A-6-ENC-20-0022 (Hanlon Residence)

CORRESPONDENCE

RE: Appeal No. A-6-ENC-20-0022 / Hanlon / 100 & 104 Fifth Street, Encinitas

Re: W18a - Application A-6-ENC-20-0022, Marco and Nicole Hanlon, 100 & 104 Fifth Street, Encinitas

EXISTING (non-conforming) STRUCTURES TO BE REMOVED
TOTAL EXISTING FOOTPRINT: **6501 SF**

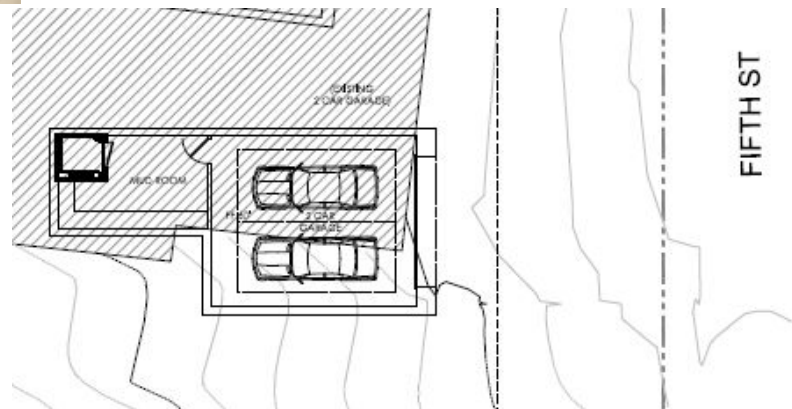
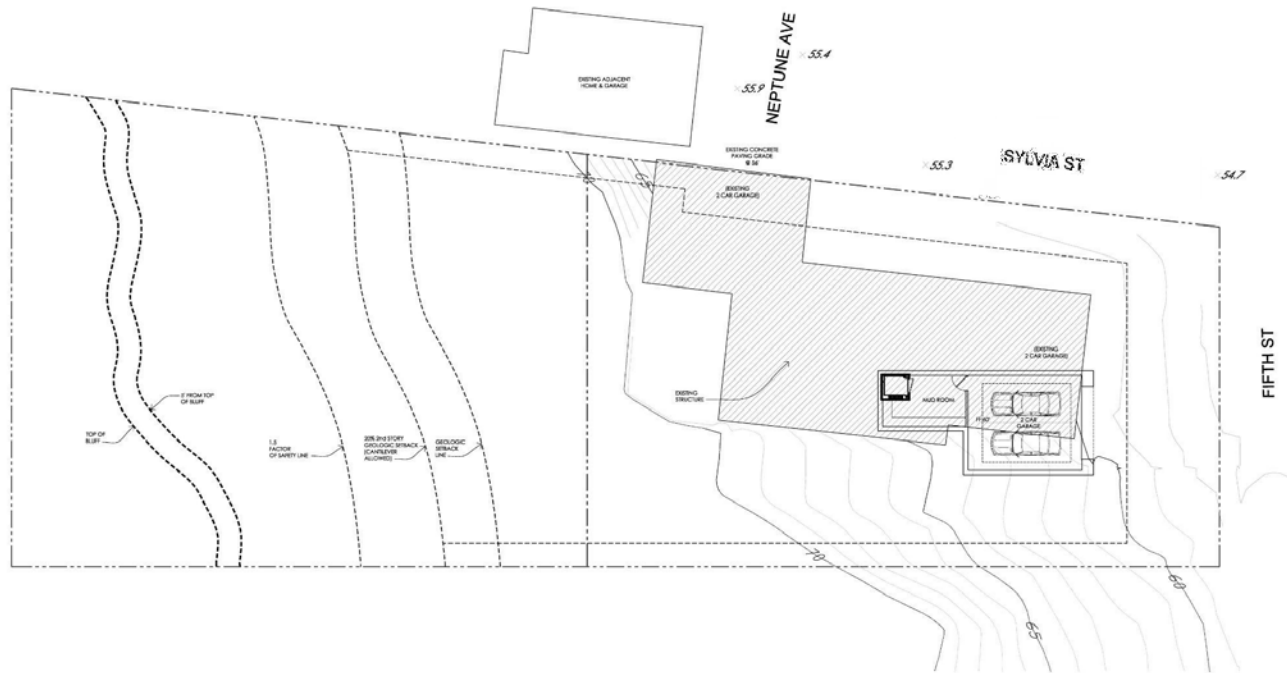
Please find attached several exhibits demonstrating the removal **ALL** of the basement garage (both the conforming and non-conforming parts) on the north side of the property, and proposing a very small basement area within the existing **conforming** basement/garage on the east side of the property so that we have interior access to the house.

Now, to address Staff's latest request, we have redesigned again, resulting in only 250 square feet of finished basement and 558 square feet of garage (both within the existing footprint), with the minor basement set back 145 feet from the bluff edge and the main house set back 62 feet

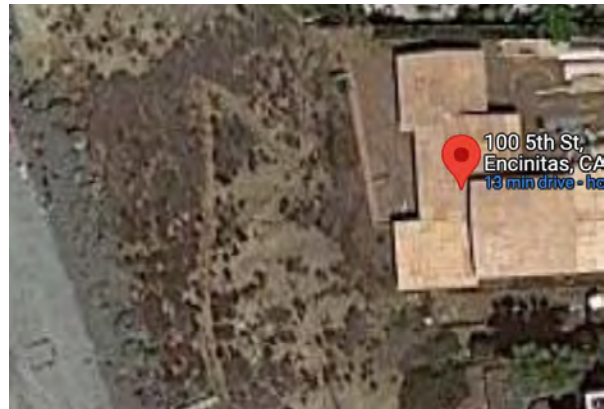
The GSL should be calculated using the ACOE's retreat rate and all proposed development should be located landward of that GSL.

Attachment PC-9, page 182, showing southern retaining from March 19, 2020 Encinitas Planning Commission Meeting⁴

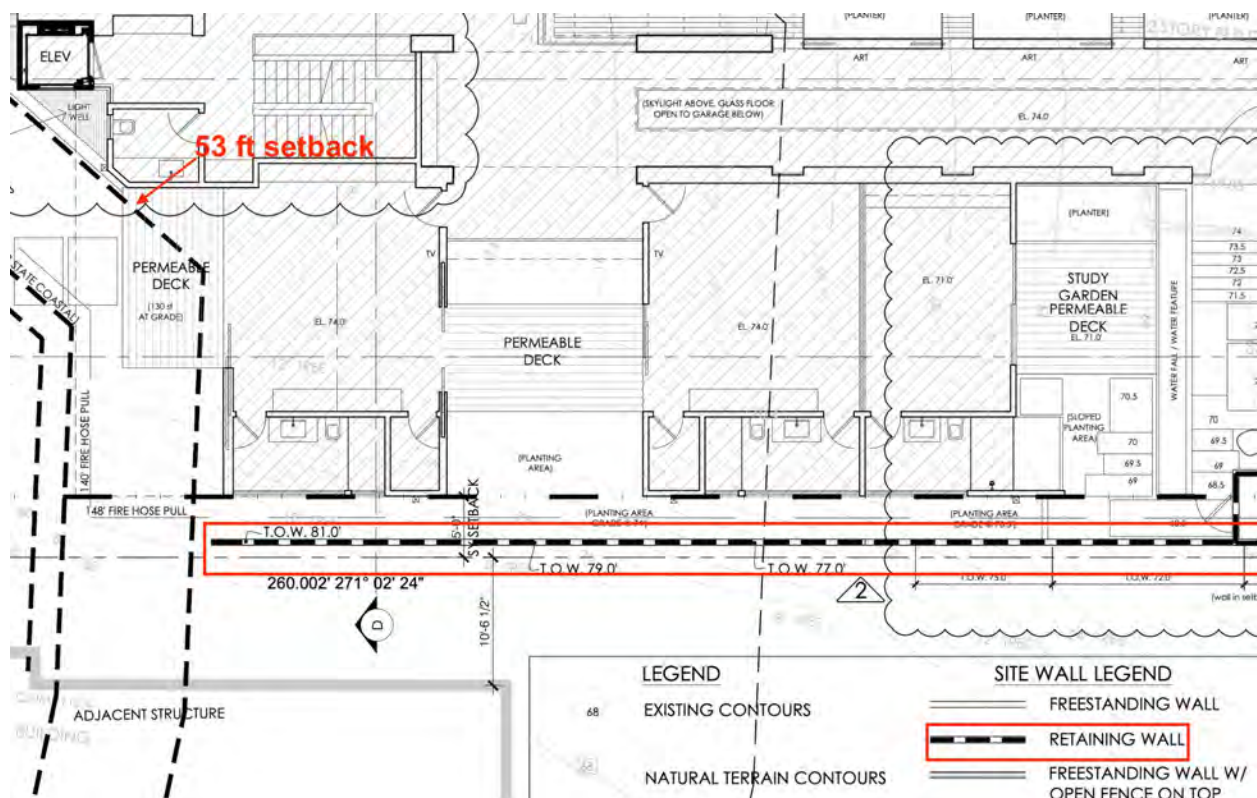
In addition, the retaining wall along the southern boundary of the subject property may be seaward of the GSL and could thus constitute a form of shoreline protection for new development. Coastal Act Section 30253 prohibits this wall and any development it is designed to protect:

The new GSL is not indicated in these planning documents from 2020, but given that the southern retaining wall extends almost to the initial 53-ft setback, it will be seaward of the new GSL as determined by the Coastal Commission. The Exhibits provided by the Coastal Commission do not include the above drawing that was submitted to the Encinitas Planning Commission. If the southern retaining wall is removed from the plans or is not seaward of the final GSL under review by the Coastal Commission, then this comment may be disregarded. However, if the plans include the southern retaining wall seaward of the GSL then this comment should be considered and the exhibits updated to reflect removal of the retaining wall.
